Project No. 25-0067.00

June 11, 2026

ADDENDUM NO. 3
TO THE
DRAWINGS AND PROJECT MANUAL
FOR
NEW OPPORTUNITY AWARENESS CENTER
KATY INDEPENDENT SCHOOL DISTRICT
KATY, TEXAS

SHEET NO.
P1.11

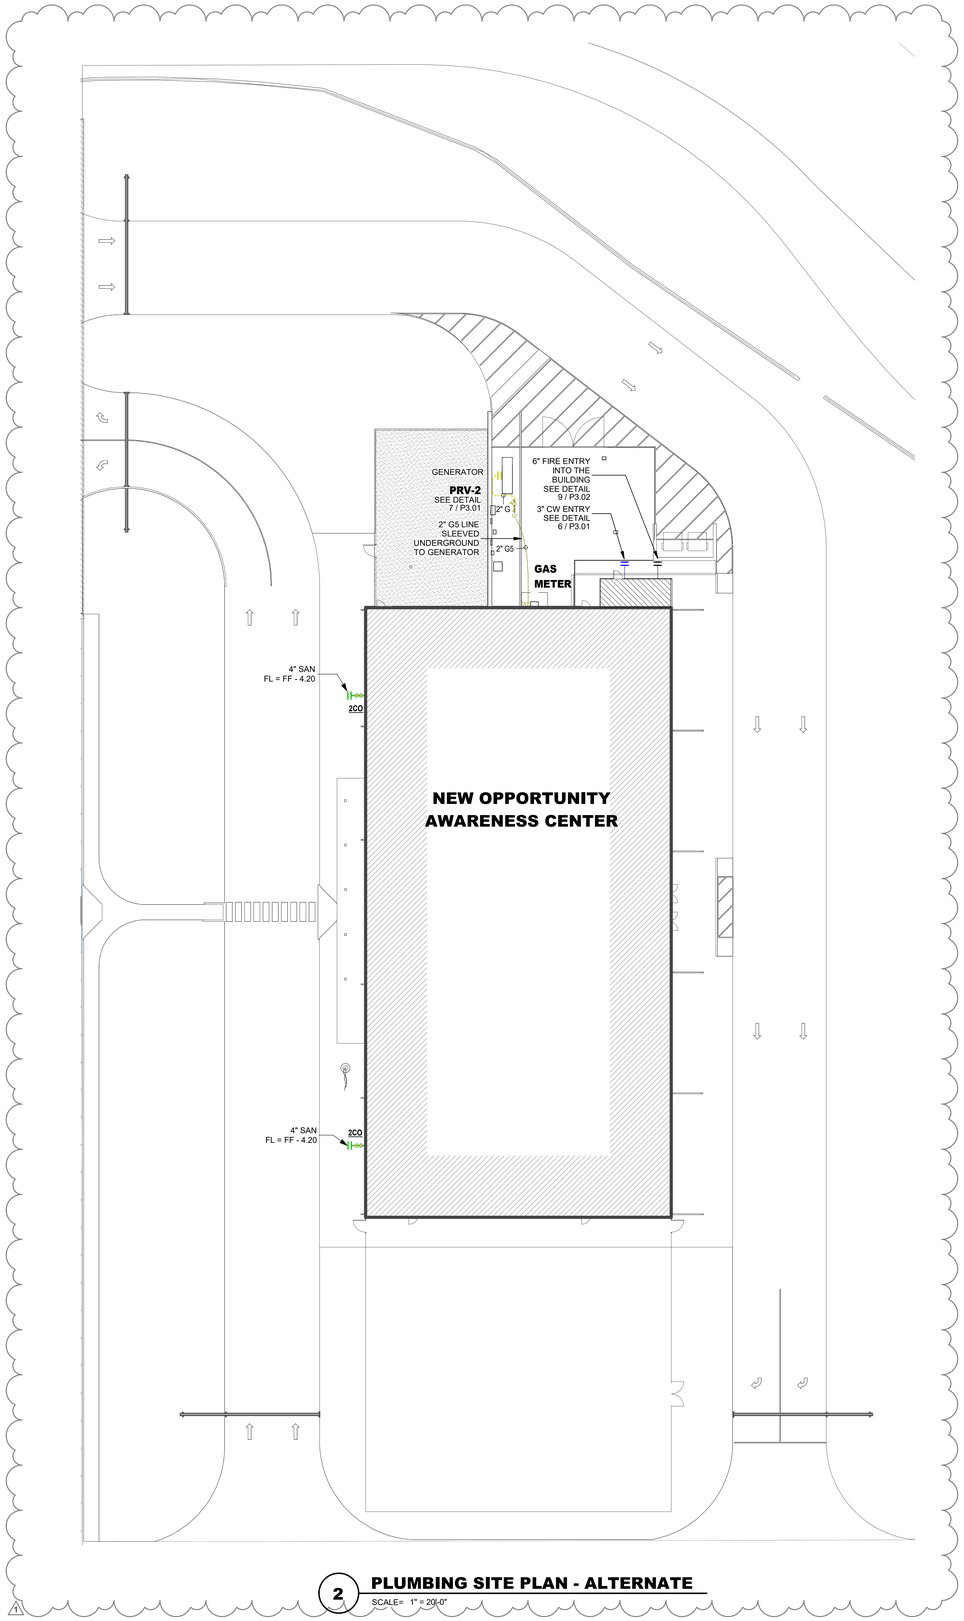
13. SHEET P1.11 — PLUMBING SITE PLAN

A. Added gas piping routing to serve the emergency generator.

B. Added alternate site plan showing the expanded riser room configuration for the fire pump and domestic water booster pump equipment.

3 PLUMBING LEVEL ONE FLOOR PLAN - ALTERNATE

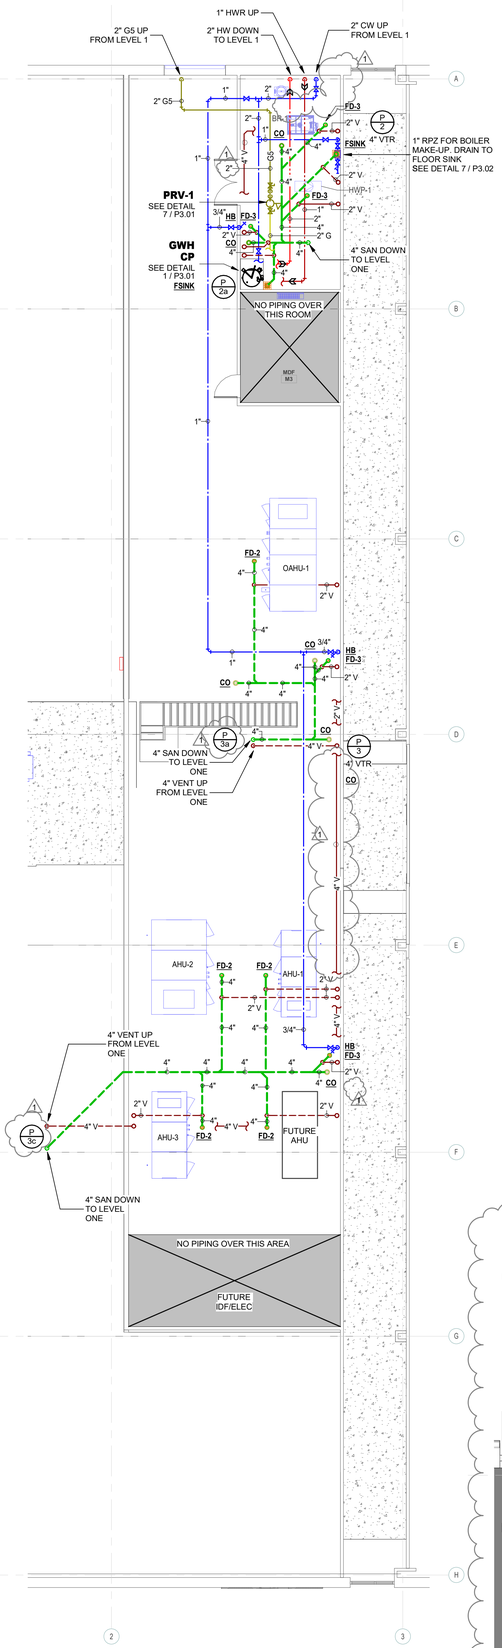
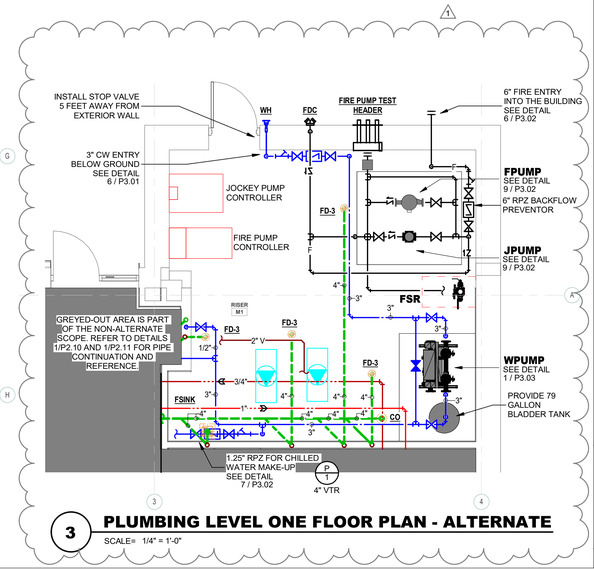
15. SHEET P2.11 — PLUMBING LEVEL ONE FLOOR PLAN

A. Added two wall hydrants on the north exterior wall.

C. Revised backflow preventer representation for improved plan readability.

E. Added alternate floor plan option showing fire pump and domestic water booster pump layouts.

SHEET NO.
E1.11

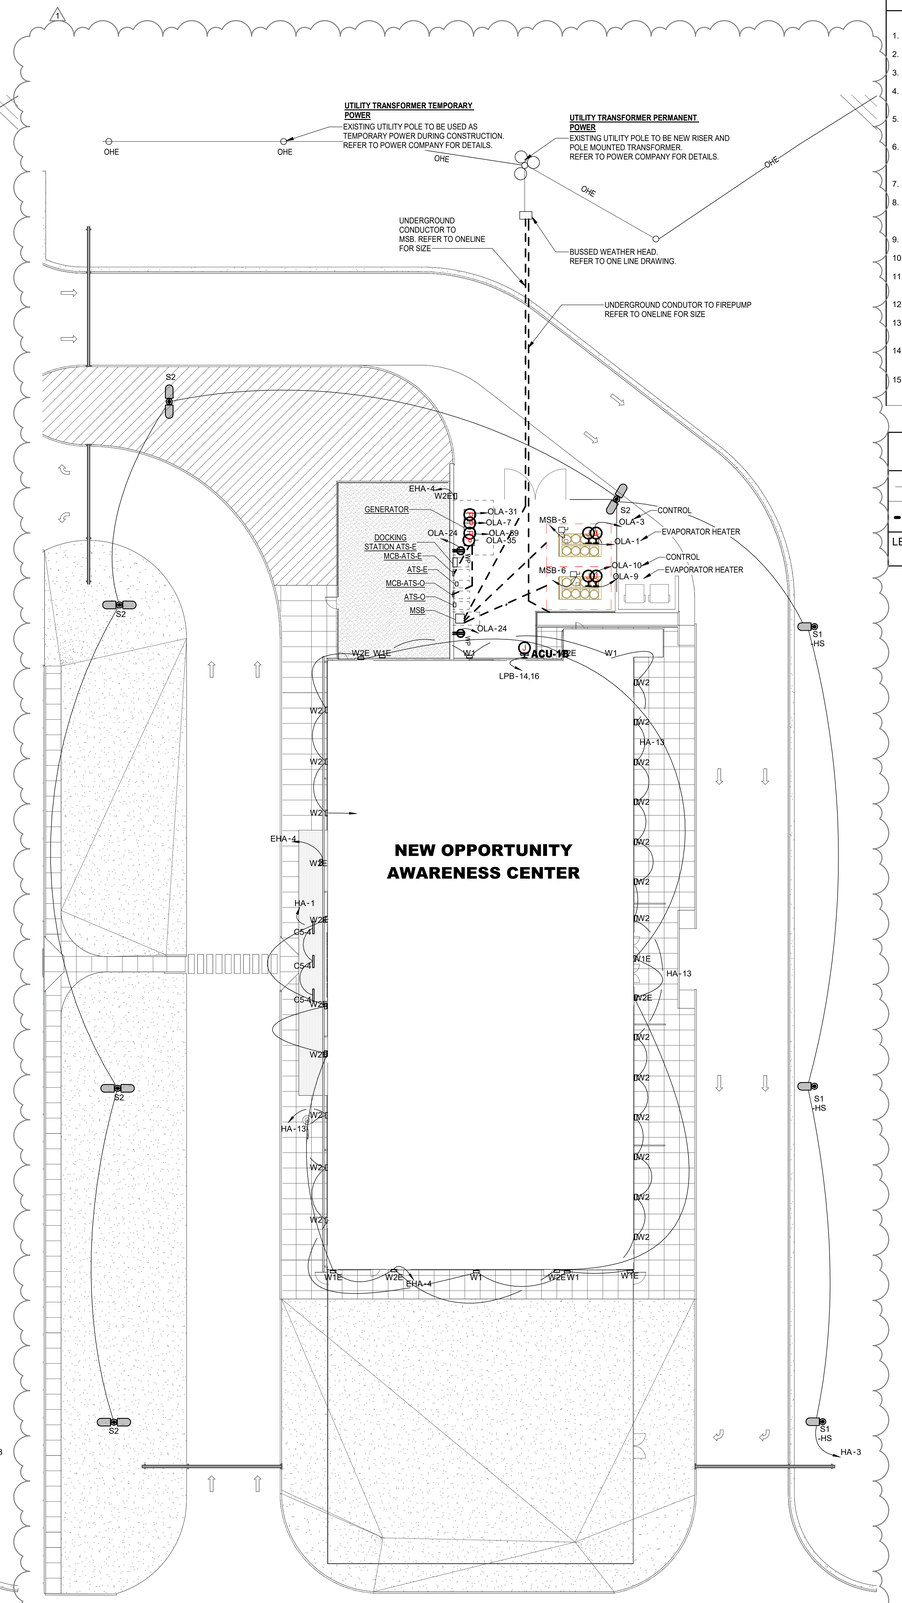
21. SHEET E1.11 - ELECTRICAL SITE PLAN

3 ELECTRICAL FIRE ALARM PLAN - ALTERNATE

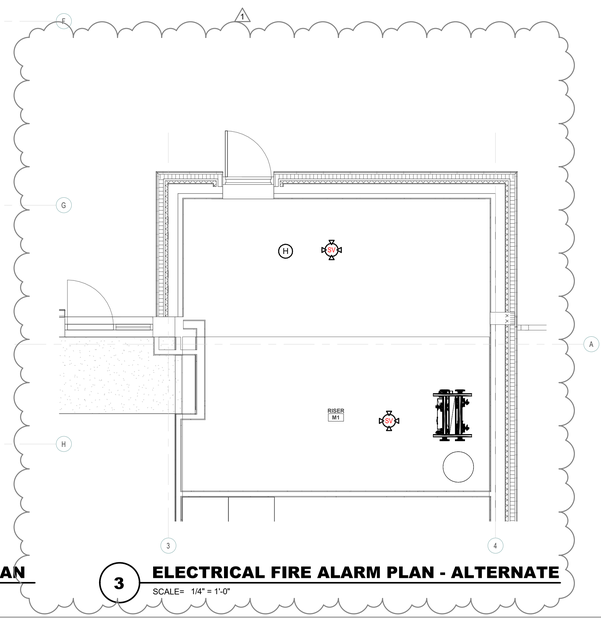
24. SHEET E2.31 – ELECTRICAL FIRE ALARM LEVEL ONE CEILING PLAN

A. Fire alarm devices added to the pump room.
